RE: Amendment to Registration for Registry #NR-122-D-101-S

We wish to amend our Registry of Radioactive Sealed Sources and Devices for the following Betacontrol Gauges for distribution as general licensed gauges:

Registry #: NR-122-D-101-S

Model: MK 1.0

Strahlenbelastung
Radiation dose rates
Valeurs d'irradiation

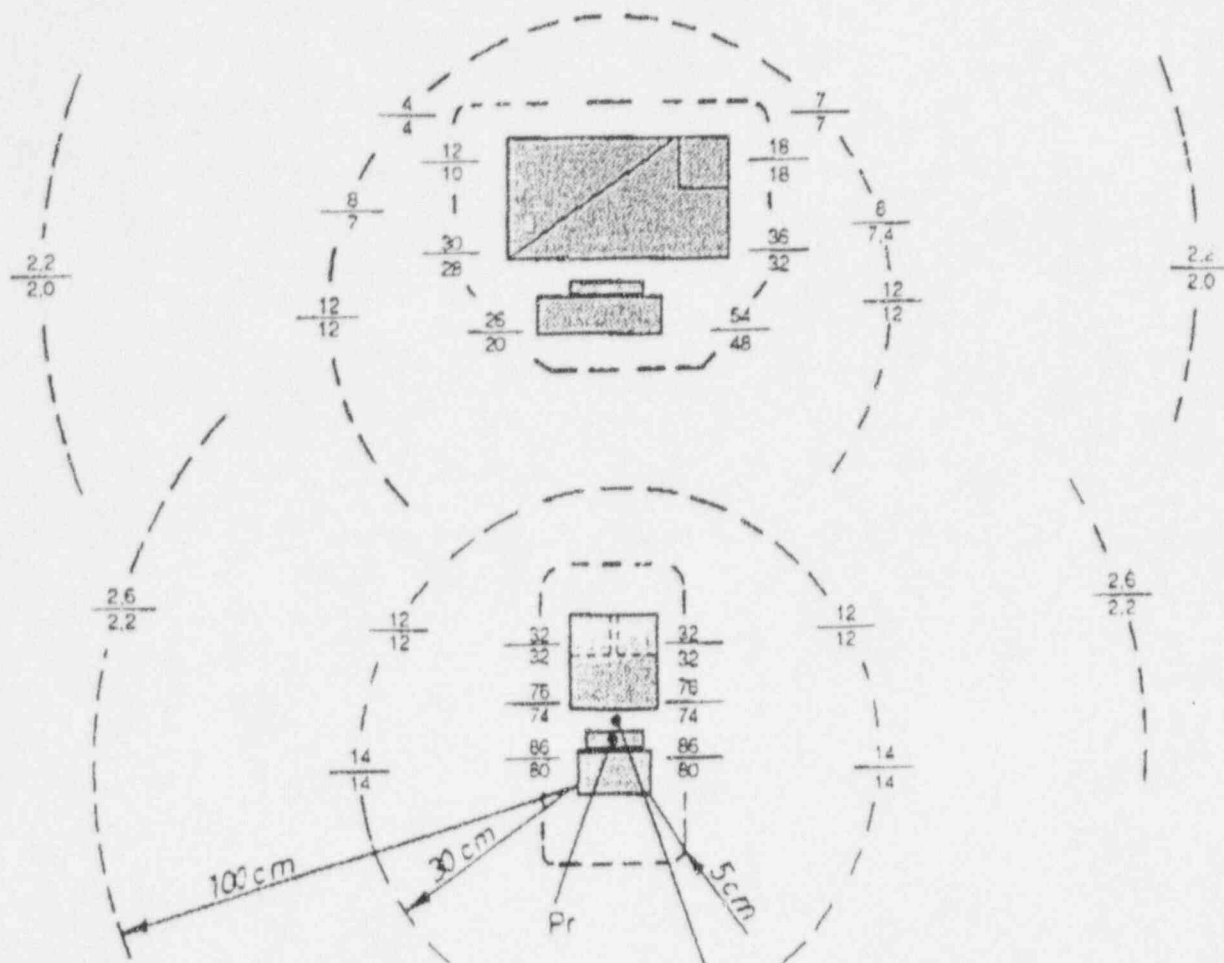
what is the minimum
distance when not shielded
(waiberg)? ~~also~~ (which)
quieting)

Assume that that would be
the case except for the 52 Mr/yr
specified as maintenance.
